MEETING NOTICE

Written Description – Gary Gundlach Warehouse Addition

461 Business Park Circle

I have completed a preliminary review of the proposed building addition for the Gary Gundlach Warehouse, 461 Business Park Circle - Plan submitted 10/17/11. As noted, additional information may be required to be provided or shown on the plans. A meeting is scheduled for November 1, 2011 of which you will receive notice.

C1.2

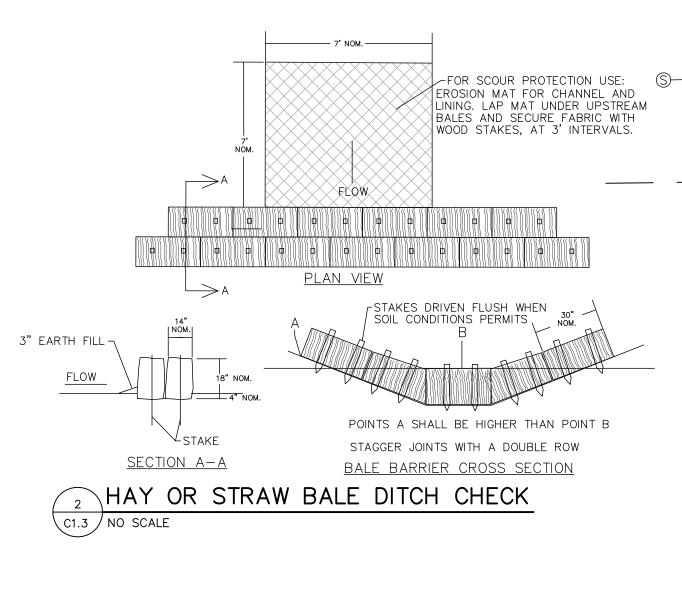
- d. Exterior Lighting. See #7 above.
- e. Clearing, grading, and drainage plan showing proposed clearing limits, existing and proposed contours at two foot intervals. **The provided grading plan with one foot contours is sufficient to meet this requirement.**

C1.3

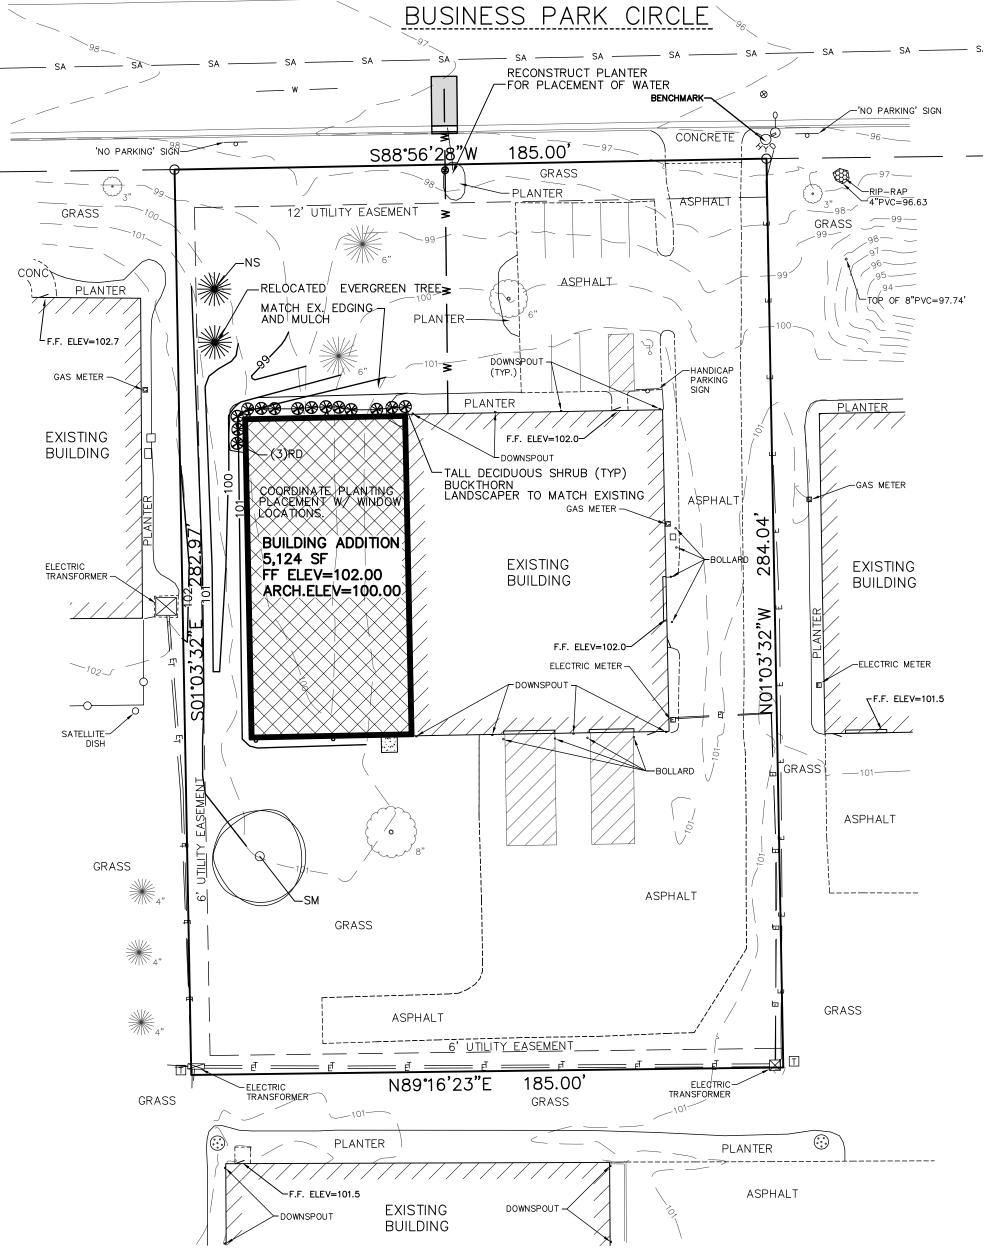
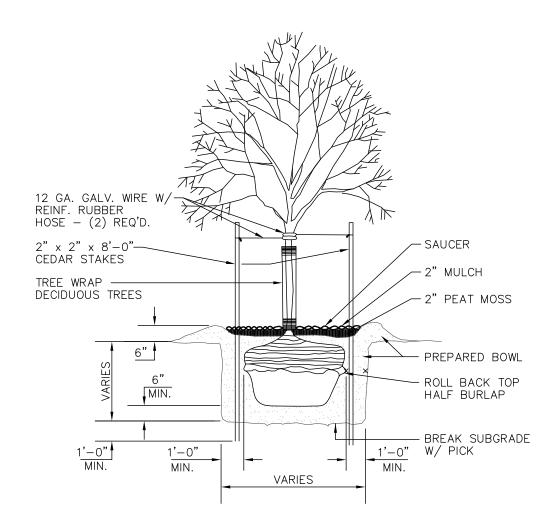
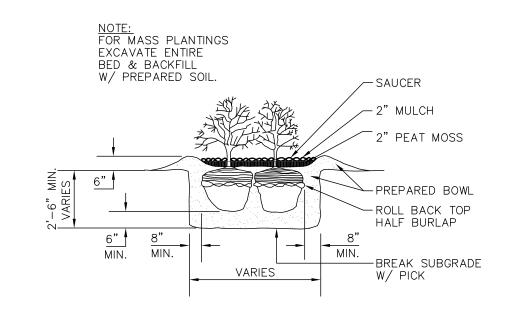
- 5. A landscaping plan which meets the requirements of section 78-604 must be provided. This section requires 81 landscaping points for the 202.48 feet of building foundation and 52 landscaping points for developed lots. The provided landscaping plan does not meet the building foundation point's requirement. There are 70 points proposed while 81 are required. Adding a few more shrubs will meet this requirement. See section 78-604 for landscaping requirements.
